**SUBJECT:** DEMONSTRATION / DELIVERY HOLD: Safety Recall 07S52:  
Certain 2007 Explorer and Explorer Sport Trac Vehicles  
Steering Gear Assembly Bolt Replacement

## CERTAIN 2007 MODEL YEAR EXPLORER AND EXPLORER SPORT TRAC VEHICLES – STEERING GEAR ASSEMBLY BOLT REPLACEMENT

FIGURE 1

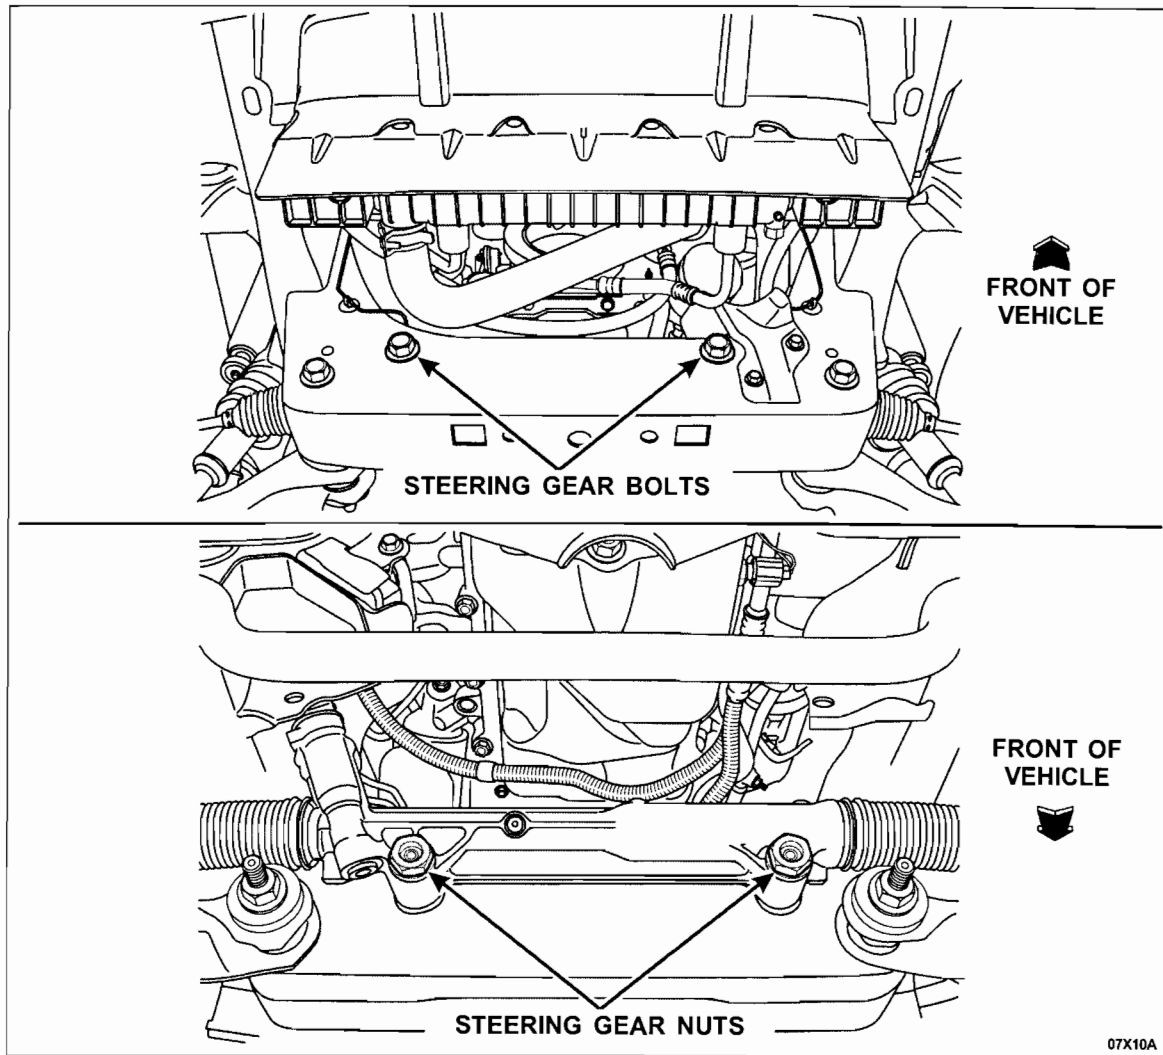
1. Raise the vehicle on a hoist.
2. Remove the steering gear bolts and nuts. See Figure 1.

3. Install **new** steering gear bolts and nuts.
4. Tighten the steering gear bolts to 350 Nm (258 lb-ft).
